ADDENDUM NO. 1

**LOWELL HIGH SCHOOL OLD POOL INFILL
AND RELATED WORK
Lowell, IN 46356**

ADDENDUM ONE

Addendum One (AD.01) to the drawings and specifications prepared by Gibraltar Design for **Lowell High School Old Pool Infill and Related Work** for Tri-Creek School Corporation, Lowell, Indiana.

E-601

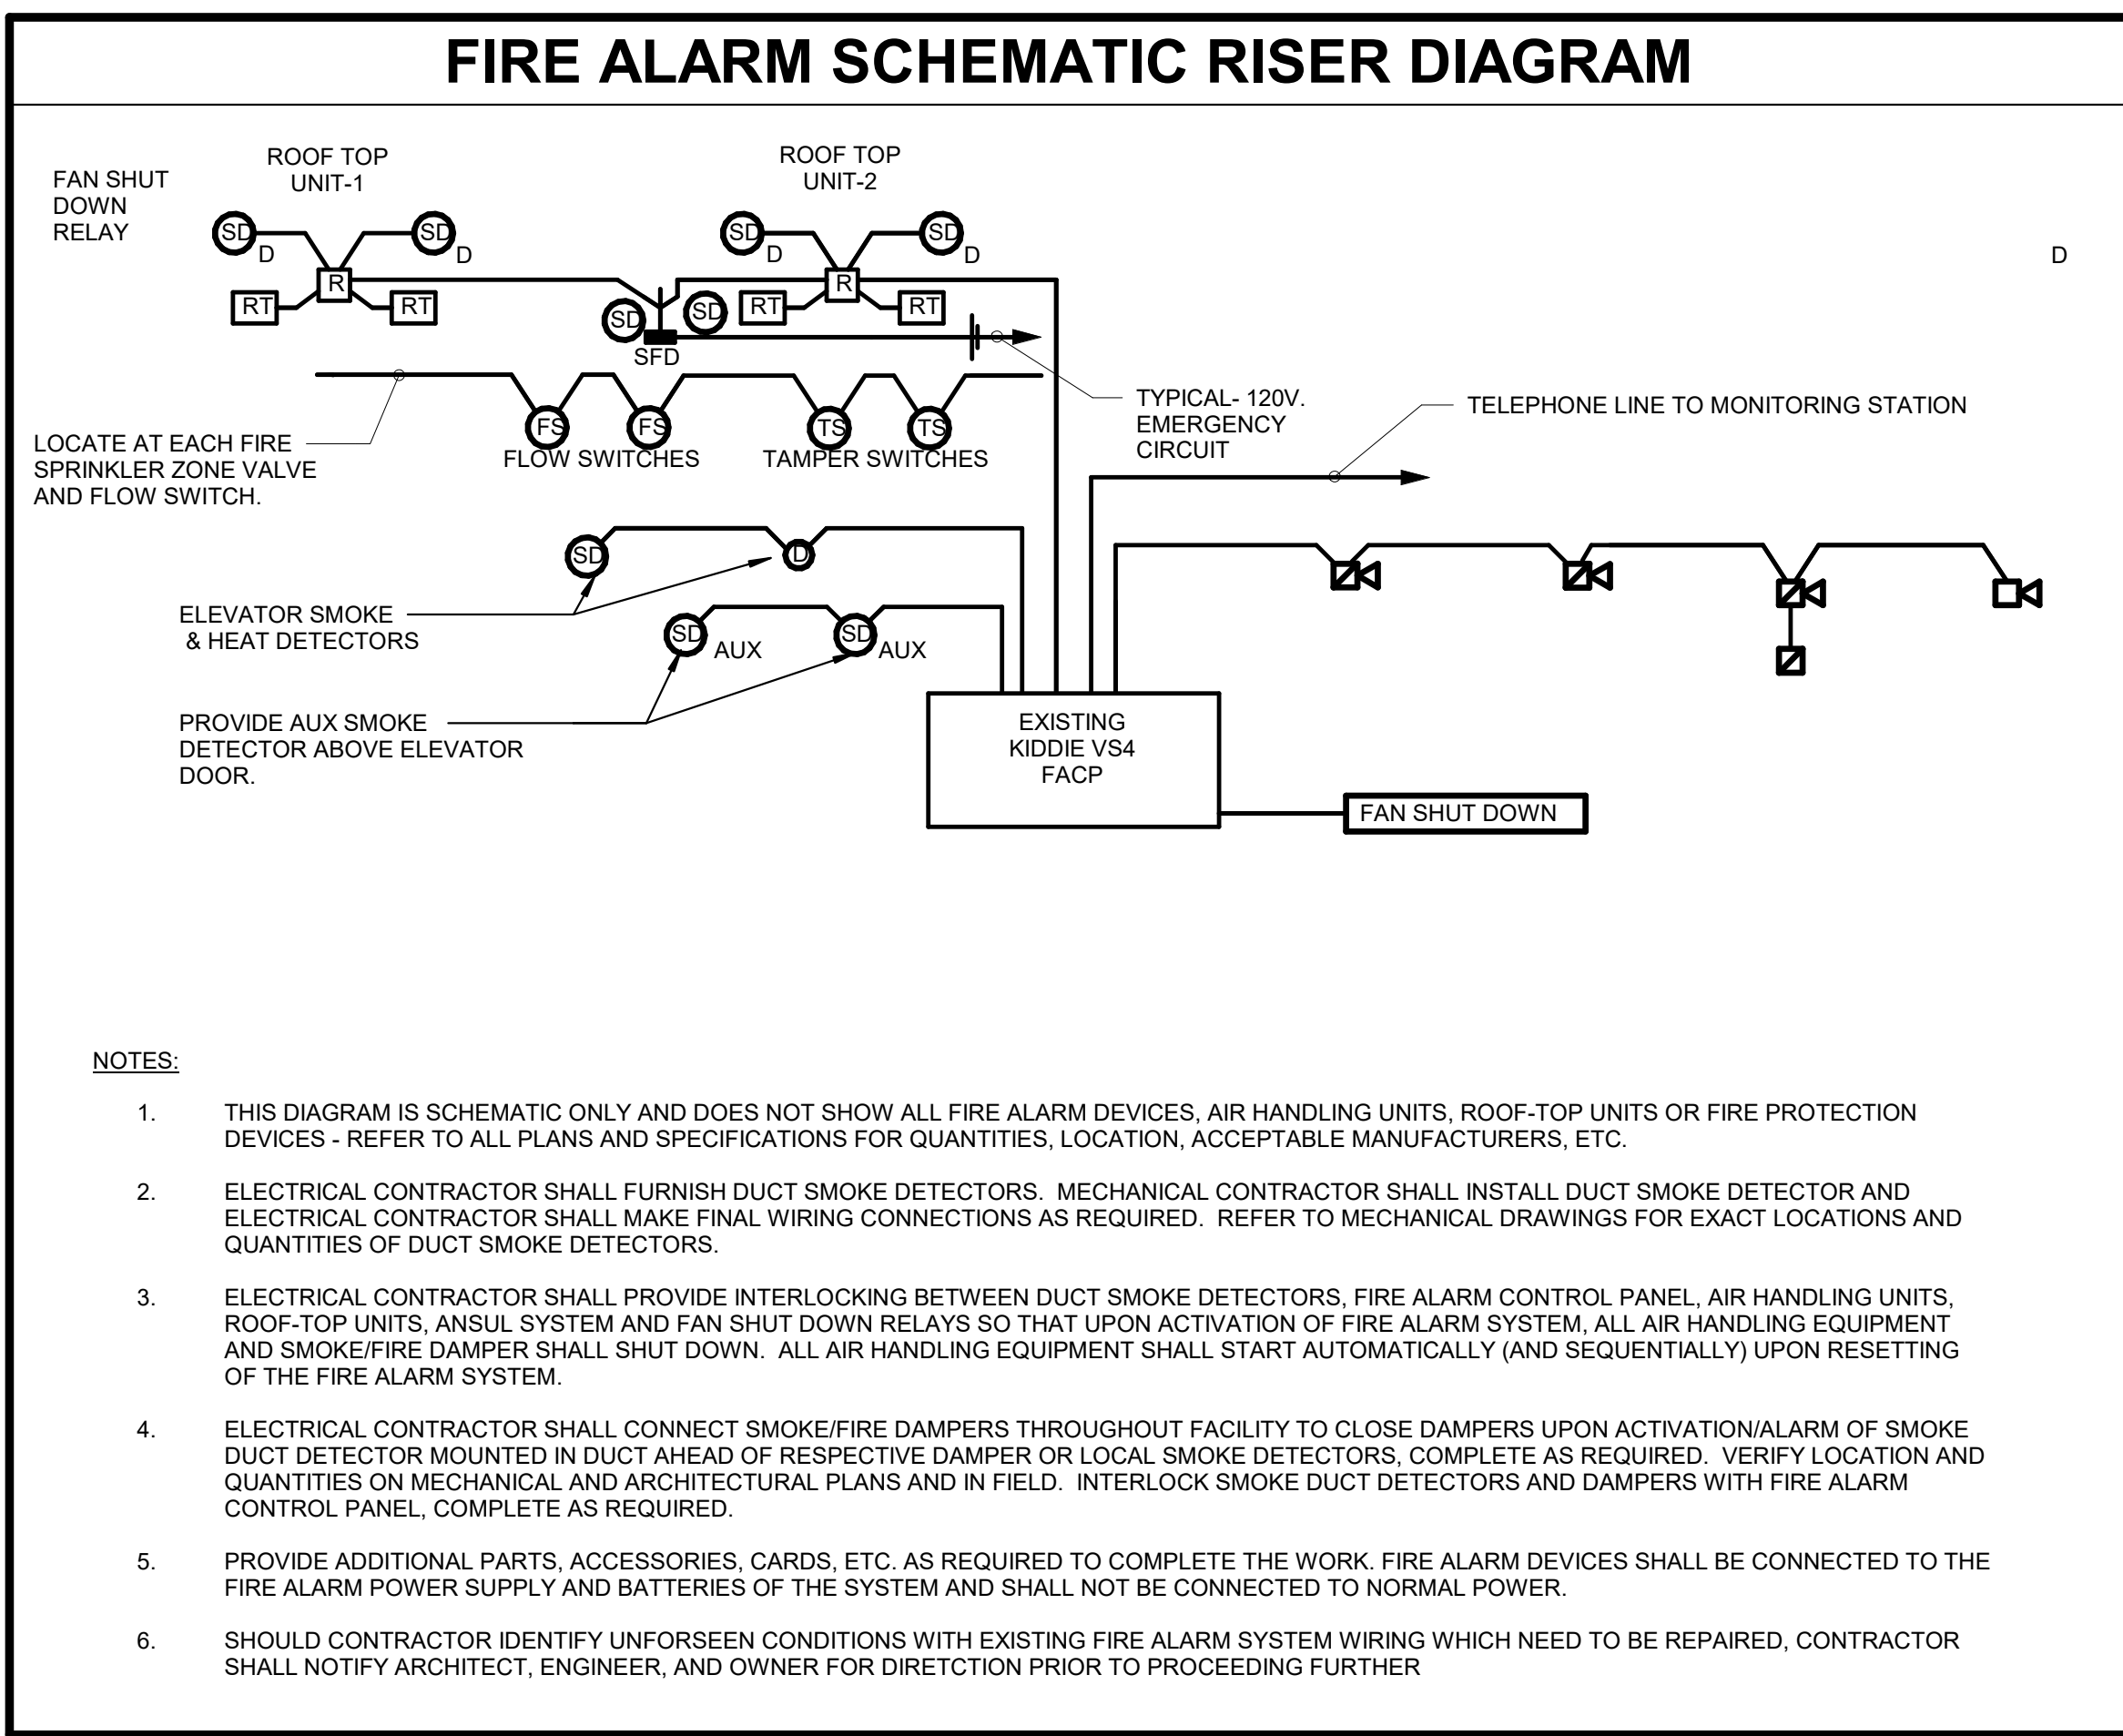
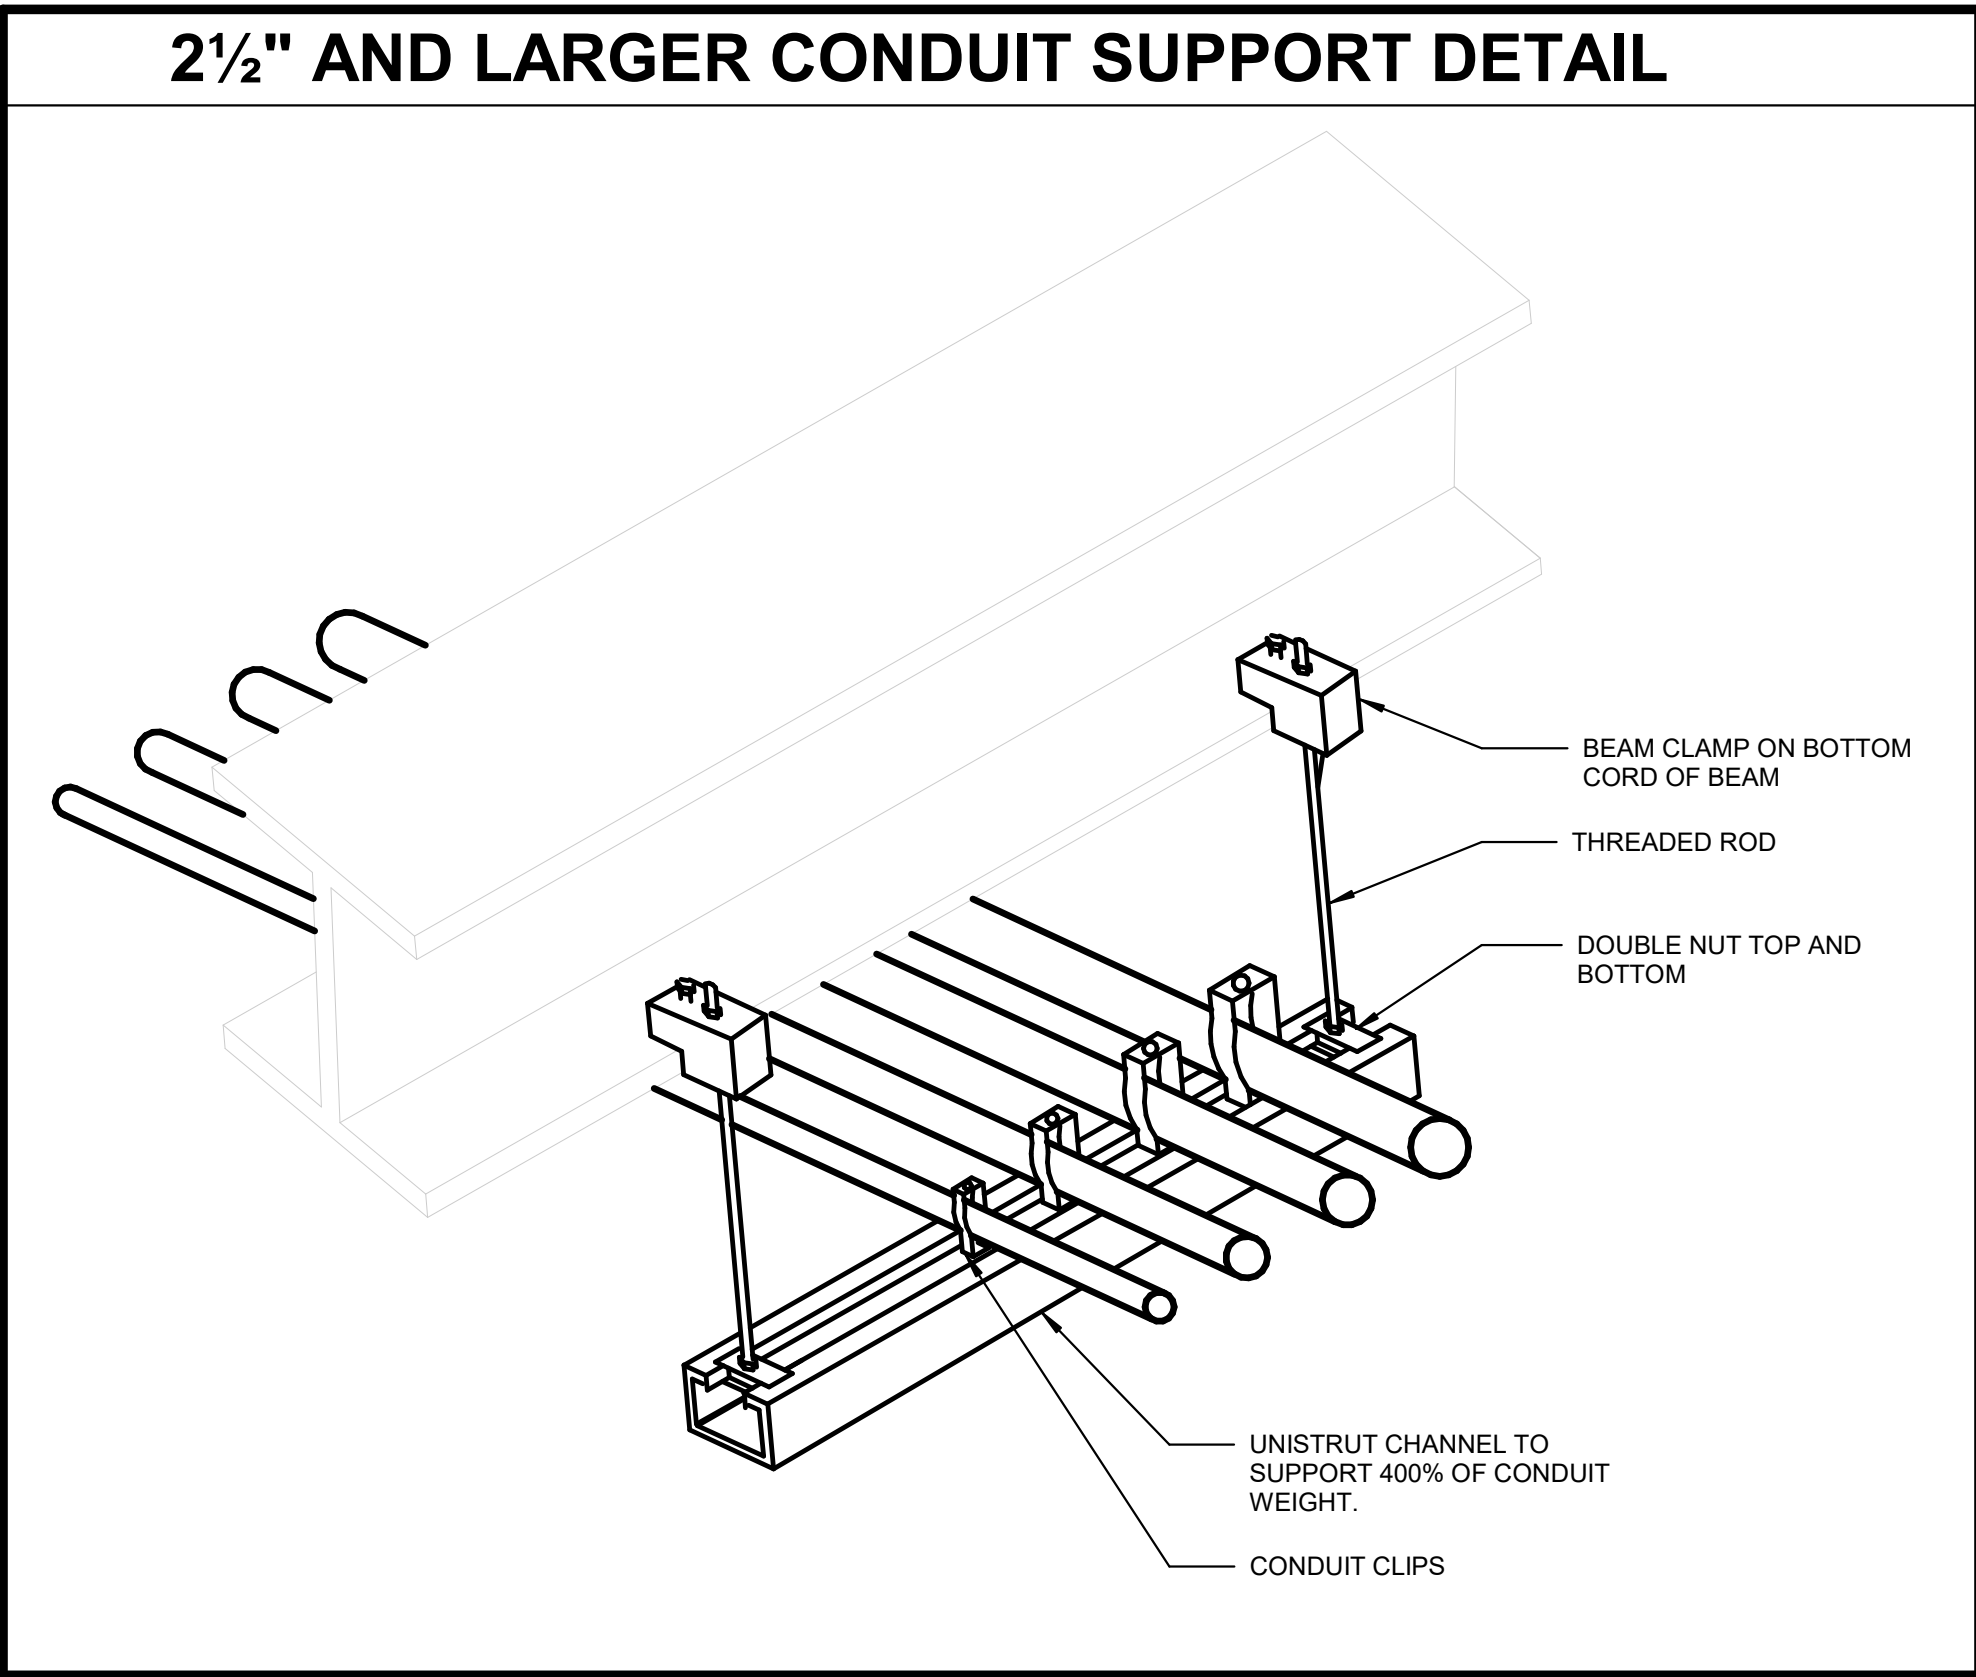
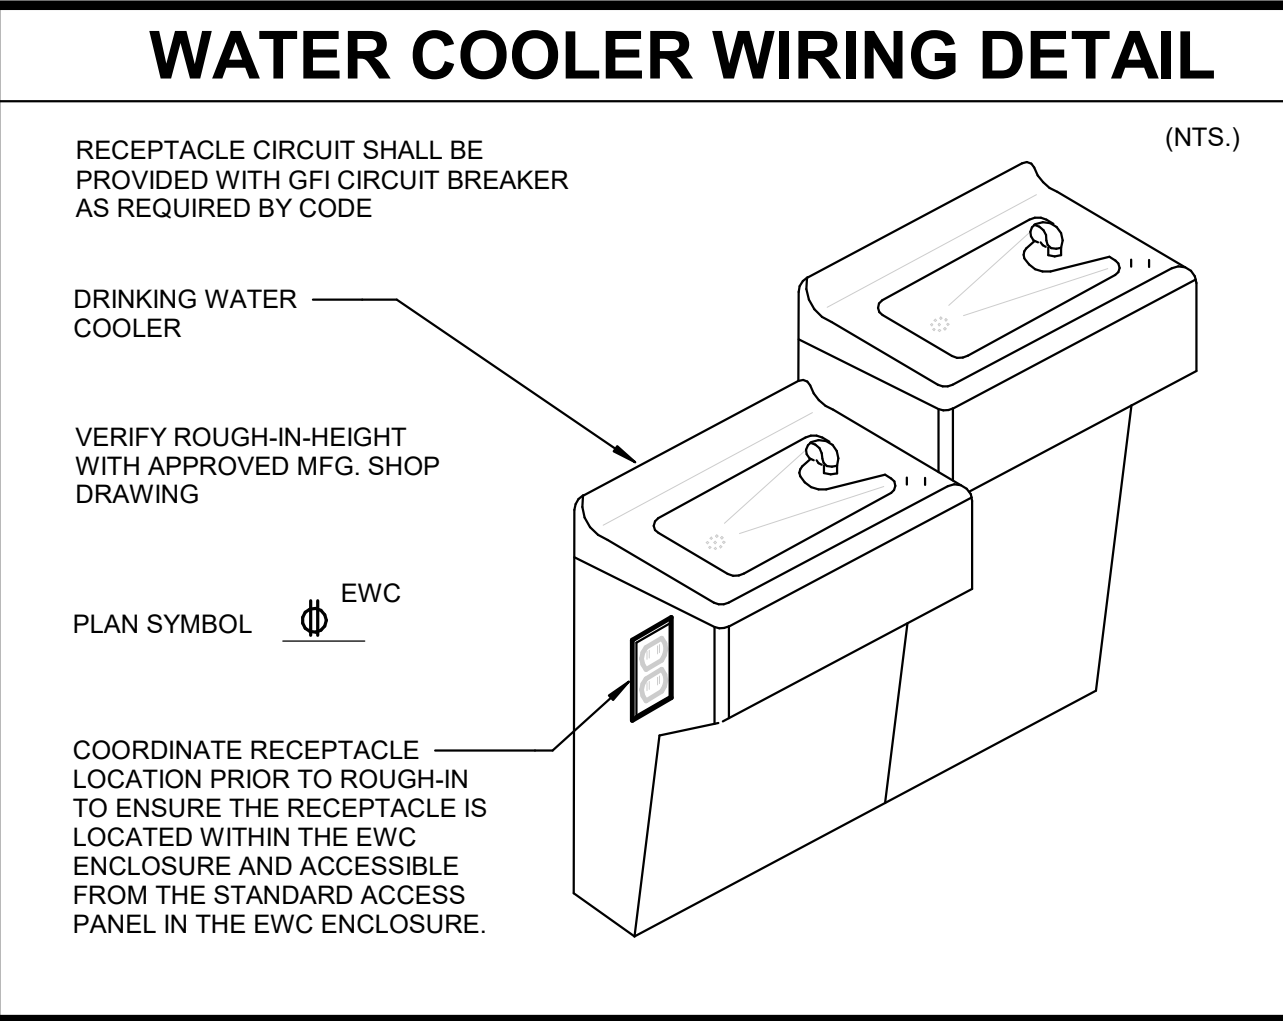
6. Sheet E-601

A. Refer to revised full size drawing included in this Addendum for the following revisions:

1. Added fixture P-2 to Interior Lighting Fixture Schedule.
